BUILDING INSPECTION PERMIT

Permit Number: 101004

This is to certify that LIEBER-ROBERT A Property Owner
has permission to build 2-story 435-sq-ft Single Family Home w/ 1 bath 1 bedroom
AT 41 BAYBERRY LN Peaks Island CBE-089-3605001

City of Portland, Maine - Building or Use Permit Application

LIPPER RESIDENCE:
PROPOSED FIRST FLOOR PLAN
1/4" = 2' 0"

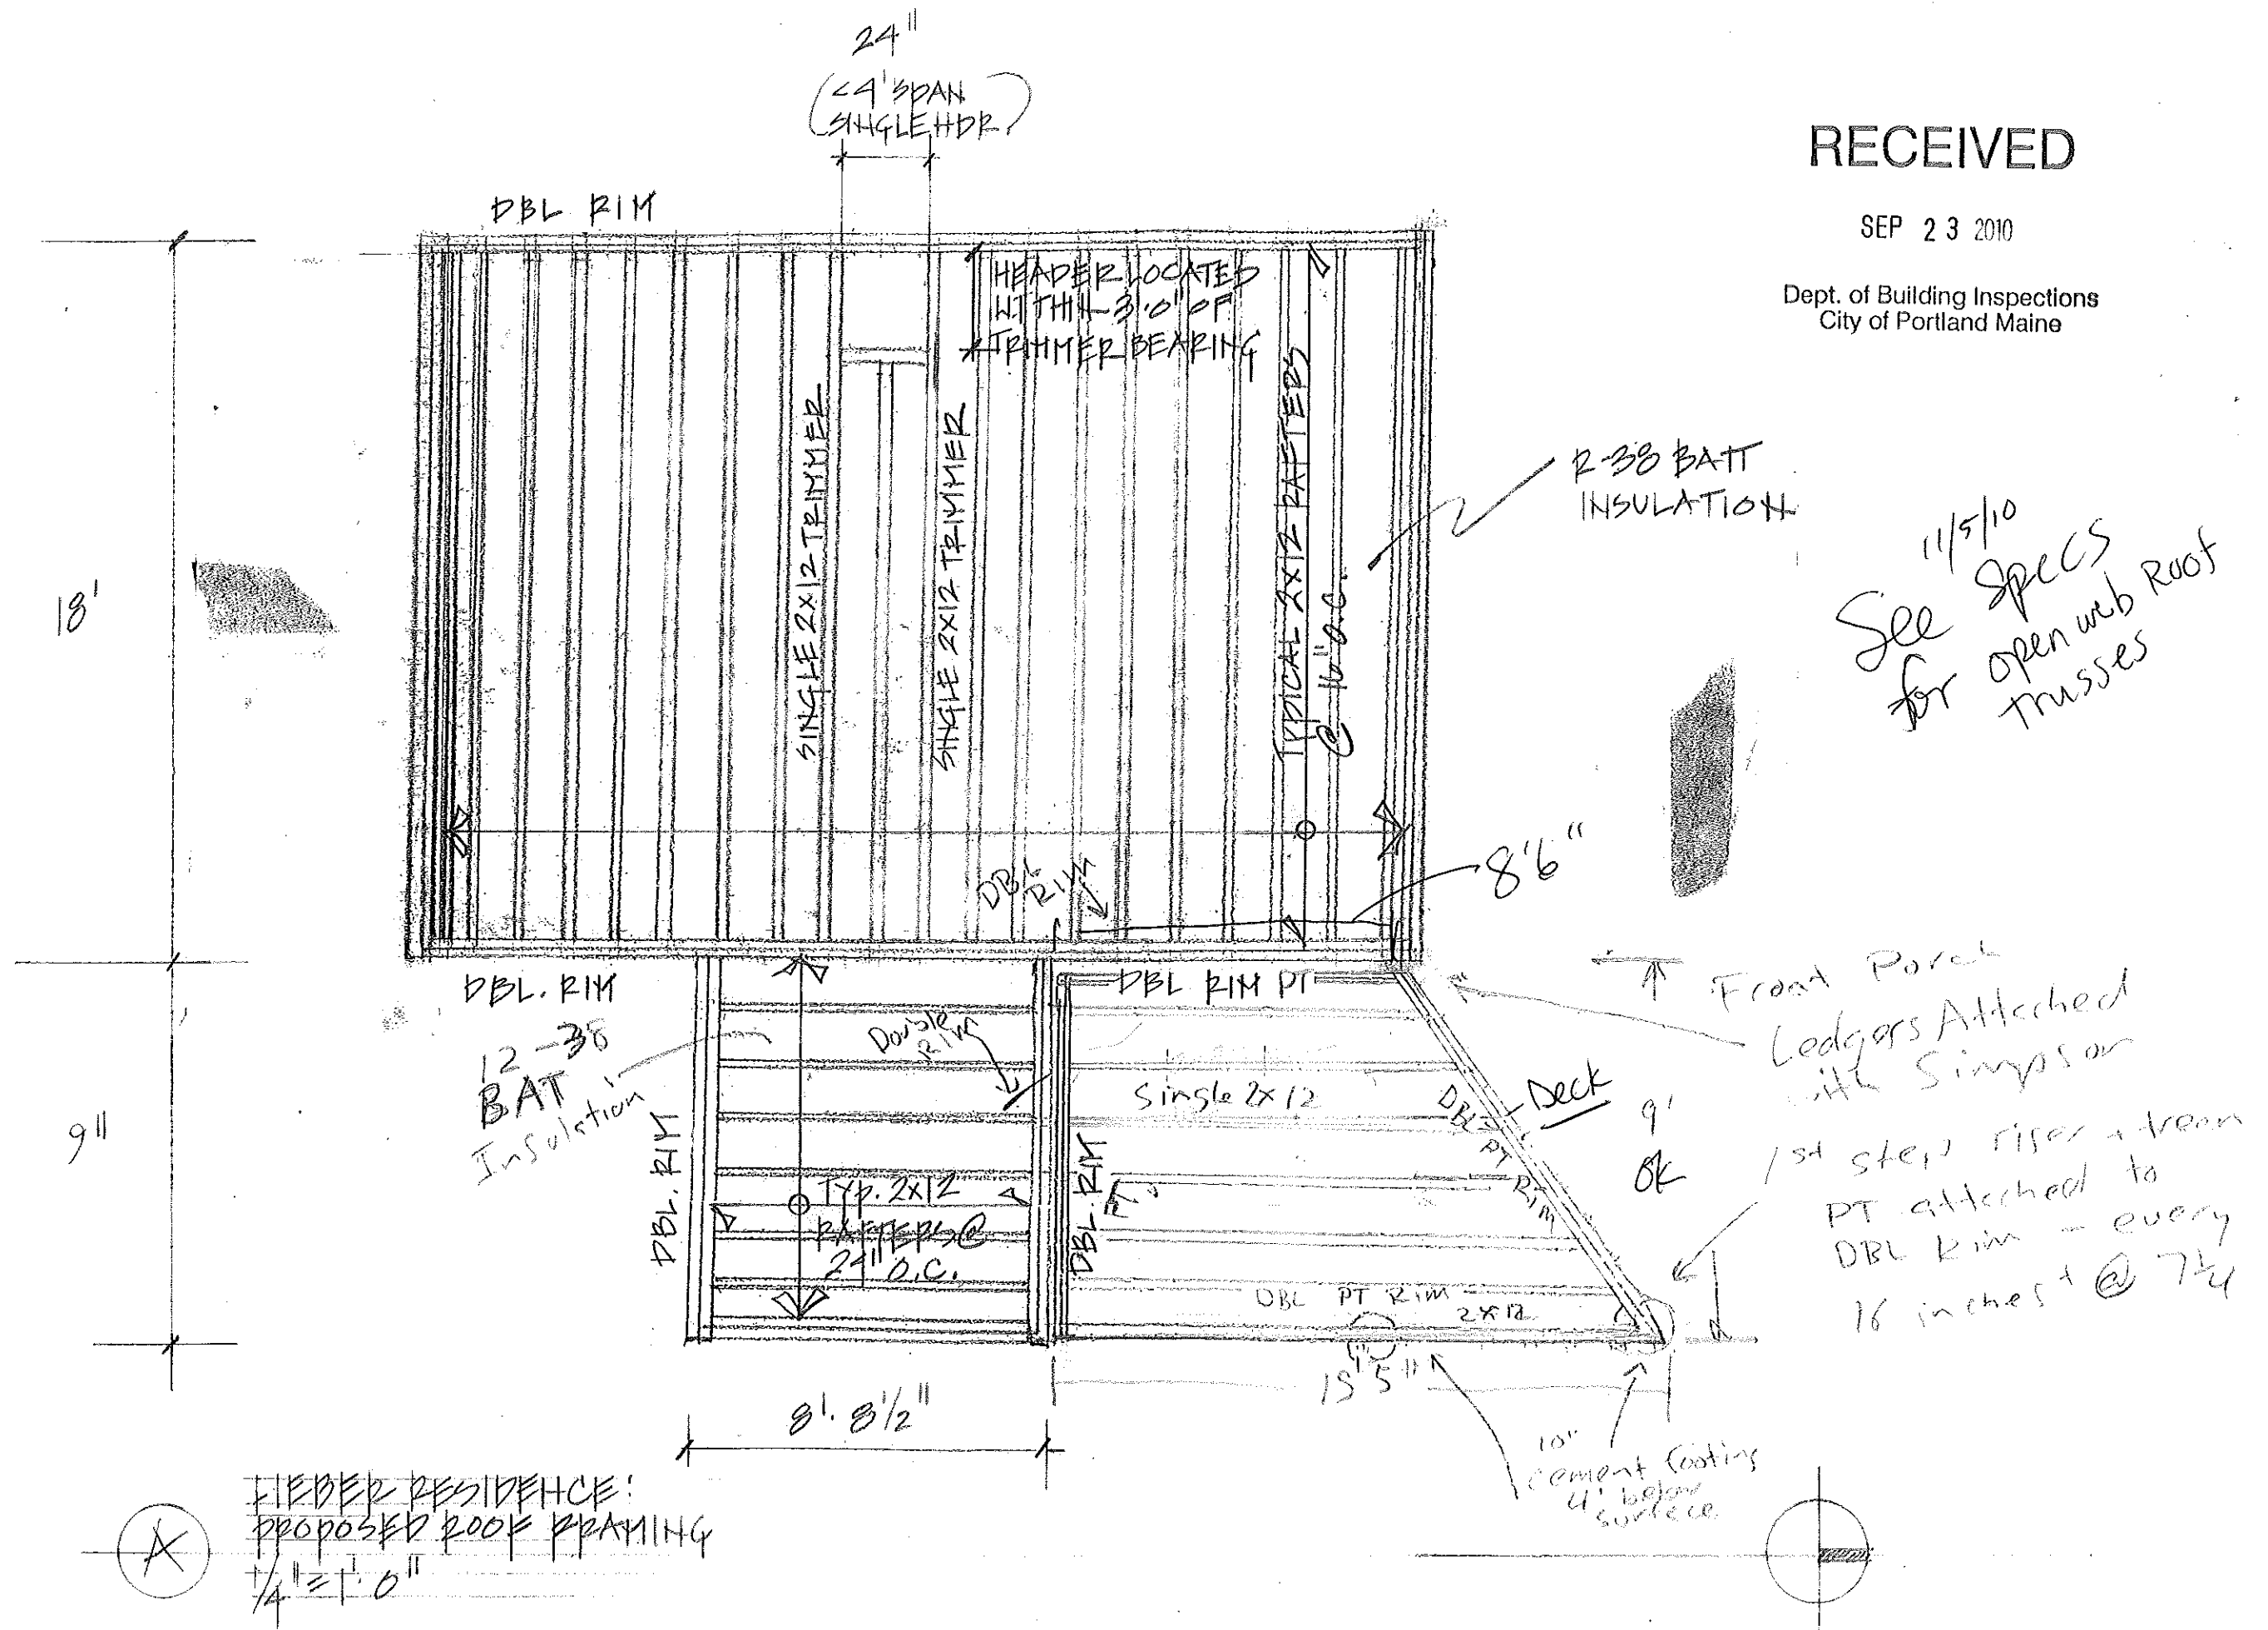
| 1. The first floor plan shows the hearth extension for the wood stove, will there also be a thickened footing for the chimney and hearth?

1. The first floor plan shows the hearth extension for the wood stove, will there also be a thickened footing for the chimney and hearth?
2. What will the roof sheathing be?
3. What is the u-factor of the windows

Yes there will be, I plan on supporting an area of 6'x6' with a large footing pinned to ledge under the woodstove. I am making the area 6' X 6' for a possible future masonry heater.

FIBER RESIDENCE:
PROPOSED ROOF FRAMING
1/4" = 1'-0"

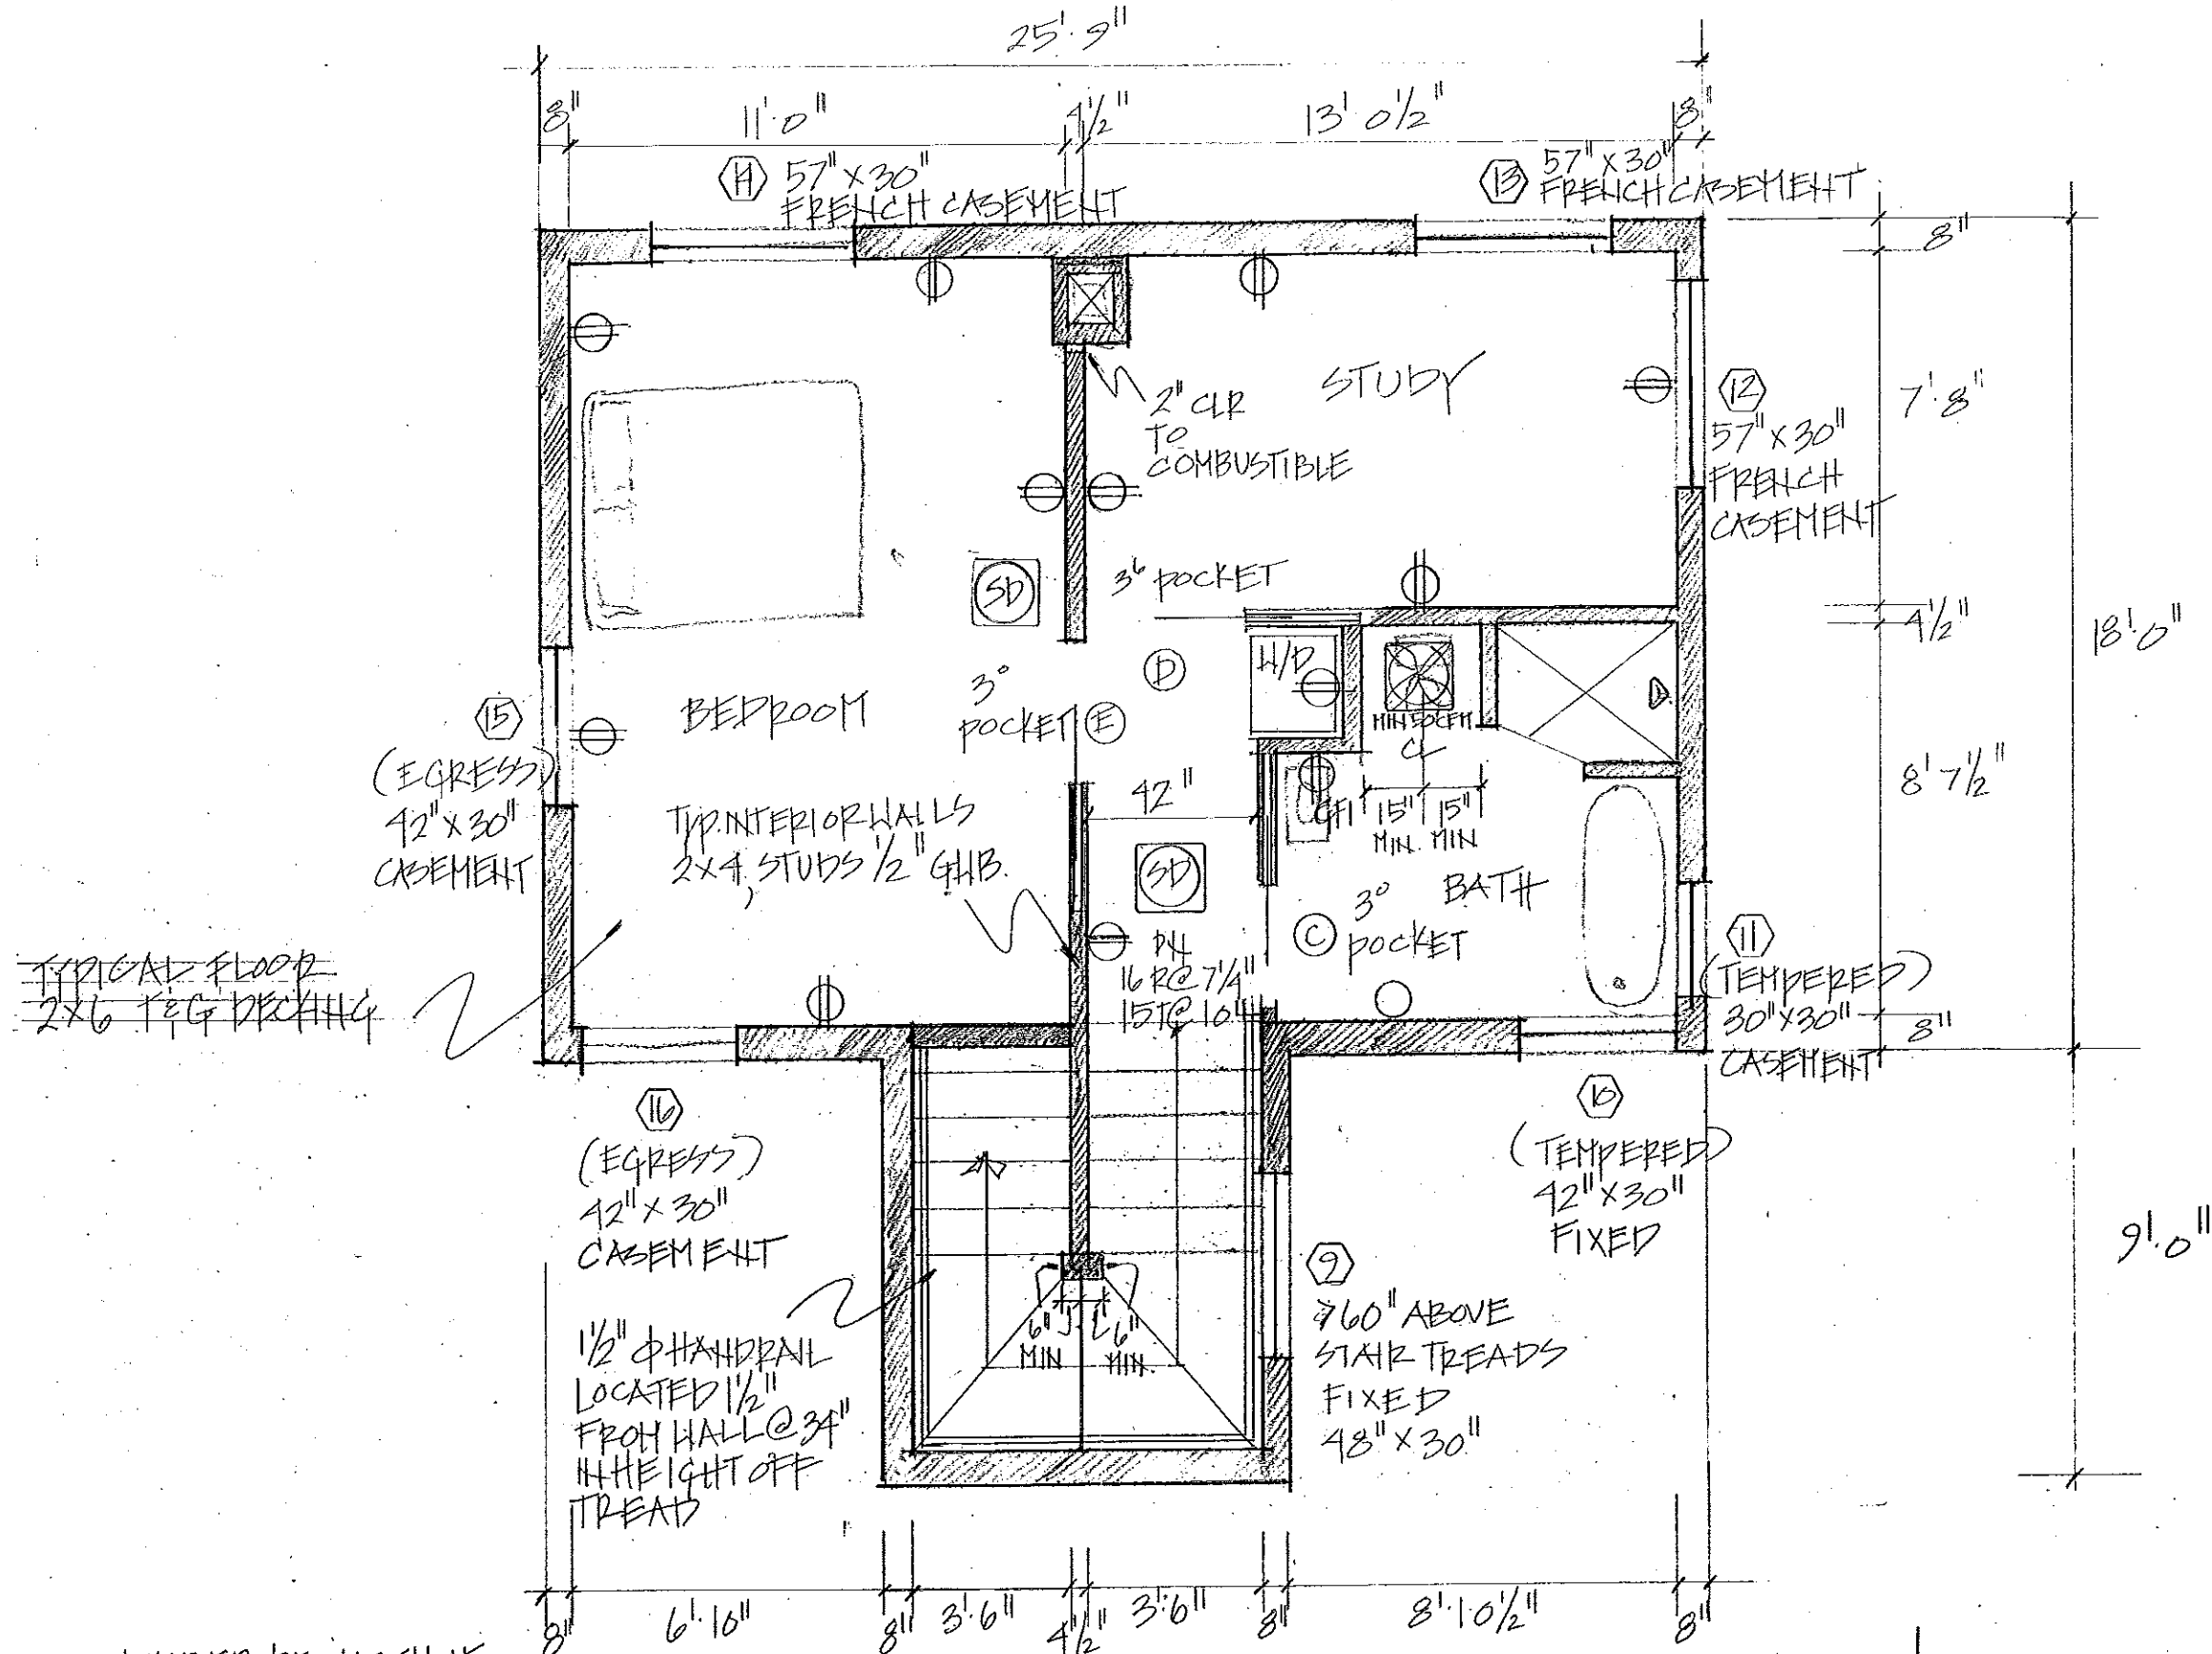
9/27/2010-jrioux: Header schedule, change to roof rafter & floor spans/ sizing needed, concrete block wall installation specs..

11/5/10
See Specs
for open web roof
trusses

Front Porch
Ledgers Attached
with Simpson
1st step riser + train
PT attached to
DBL Rim - every
16 inches @ 7/4

As for the buildings joists and rafters I now plan on using a Open Joist product, the truss system offers me more flexibility.

LIEBER RESIDENCE
 FOOTING DETAIL
 1" = 1'0"

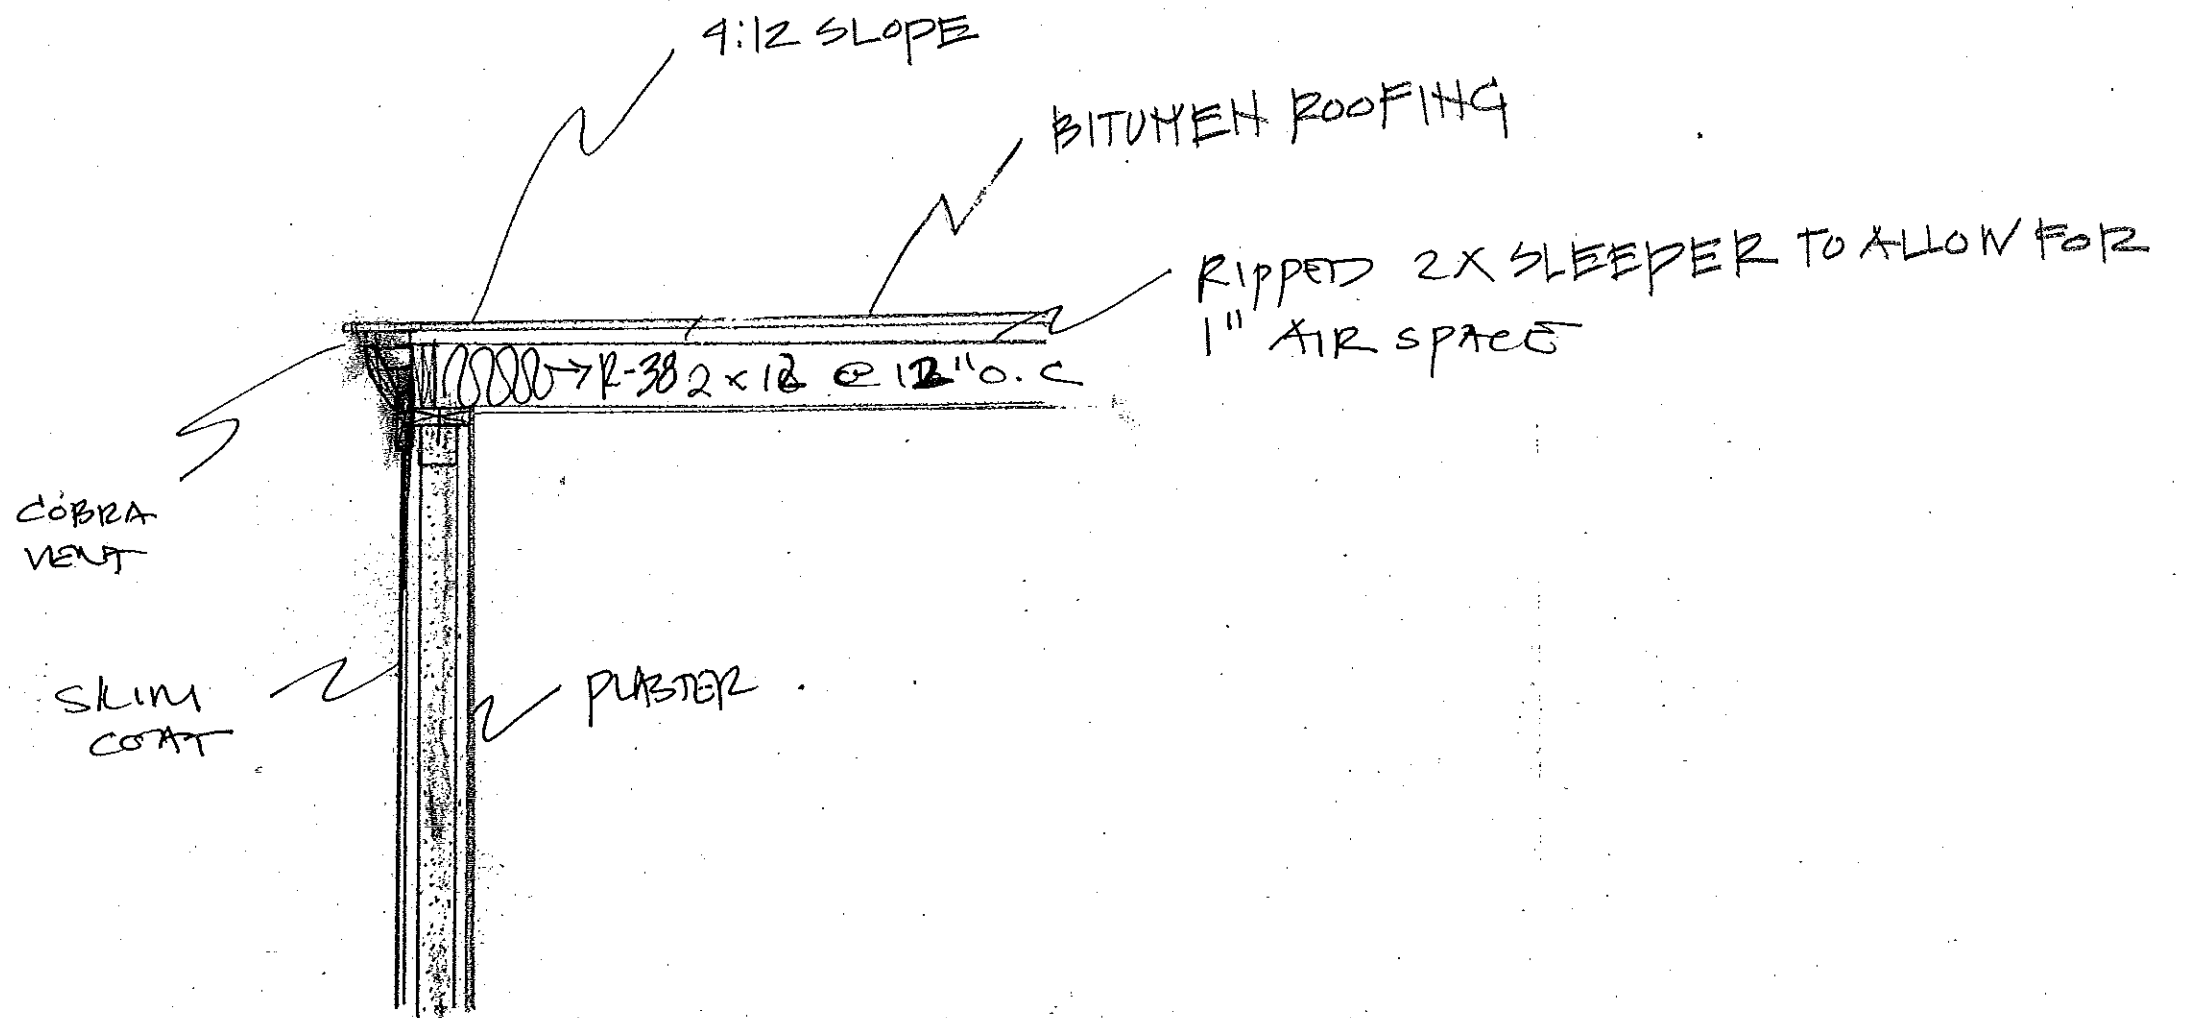
5-12-11 DW-M Rob 766-5043 Forms not in place,
rebar pins to ledge to be 6' max.

6/6/11 Meeting w/ Rob in office - he will be submitting
an Amendment - Change not using TCF's, block Frost wall
on ledge. Also changing Framing details.
Approved to continue footing forms @ 12" x 12" gmb

6-16-11 DW-M Rob 766-5043 Footings OK
